The Commission has issued the enclosed Amendment No. 26 to Facility Operating License No. DPR-26 and Amendment No. 5 to Facility Operating License No. DPR-64 for the Indian Point Nuclear Generating Units Nos. 2 and 3, respectively. These amendments consist of changes to the Technical Specifications for each license in response to your applications transmitted by letters dated August 27, 1976 and November 9, 1976. As discussed with your staff, modifications have been made to your proposed changes to meet regulatory requirements.

These amendments revise the Technical Specifications to change requirements for administrative controls.

SAFETY EVALUATION BY THE OFFICE OF NUCLEAR REACTOR REGULATION

INDIAN POINT NUCLEAR GENERATING UNITS NOS. 2 AND 3

Figure 6.2-1 Facility Management and Technical Support Organization

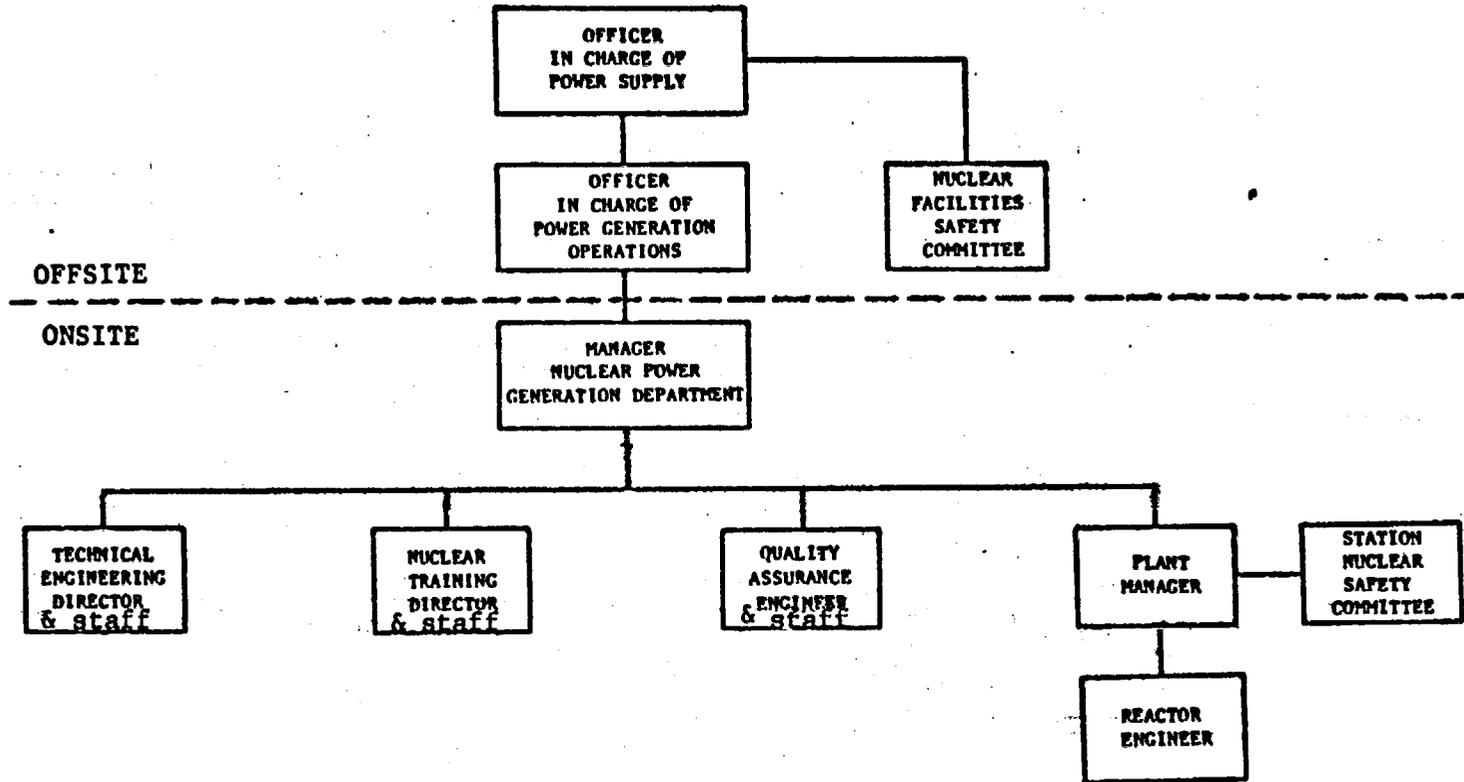
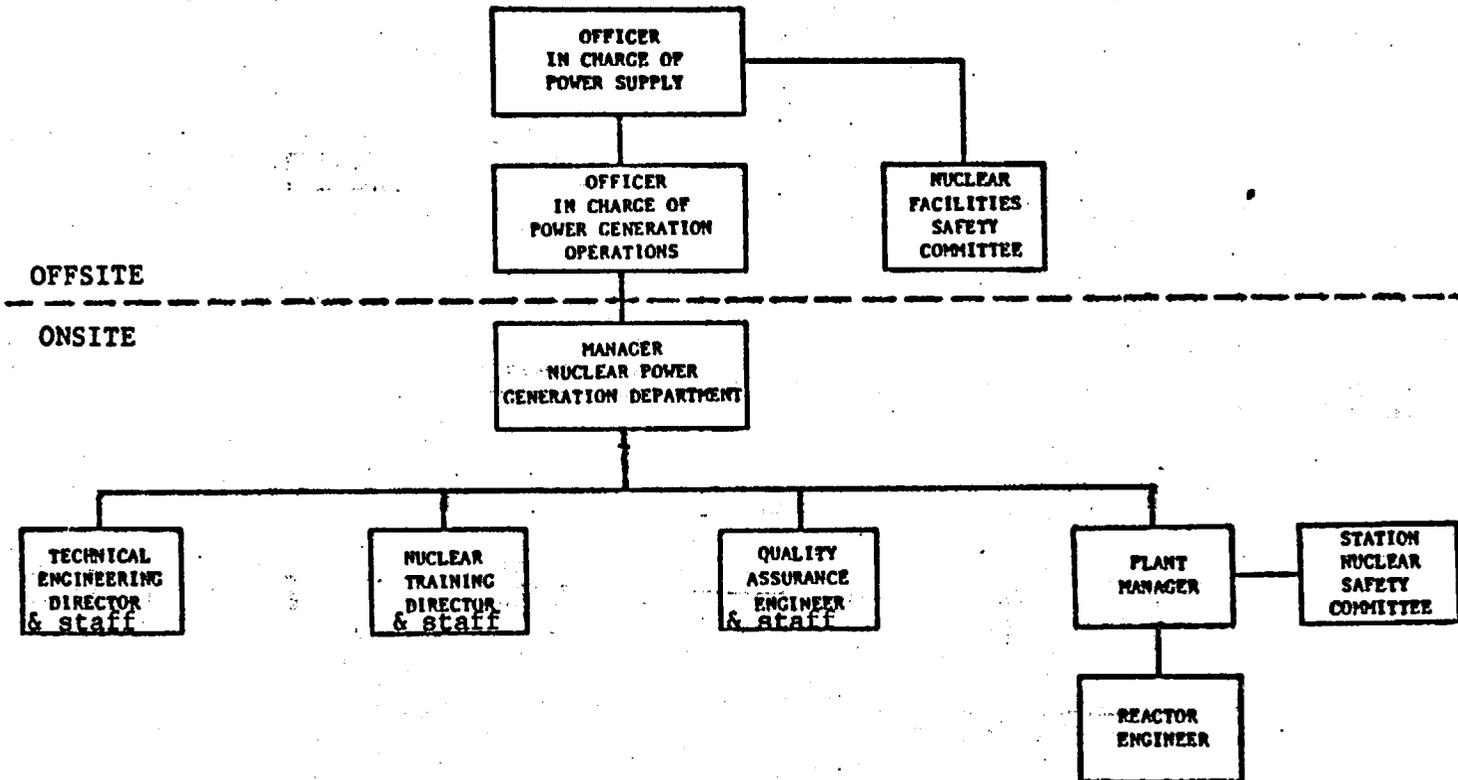
Changes were made in the organizational charts (figures 6.2.1 and 6.2.2) to more clearly reflect the fact that certain engineers and directors had staffs reporting to them. The composition of the Station Nuclear Safety Committee was modified to include the Manager, Nuclear Power Generation as a member. The highest level on-site manager would therefore be more directly informed of safety considerations and would also participate in such considerations by the committee.

6.2.1 The organization for facility management and technical support shall be as shown on Figure 6.2-1.

- 6.2.1 The organization for Facility Management and Technical Support shall be as shown on Figure 6.2-1.
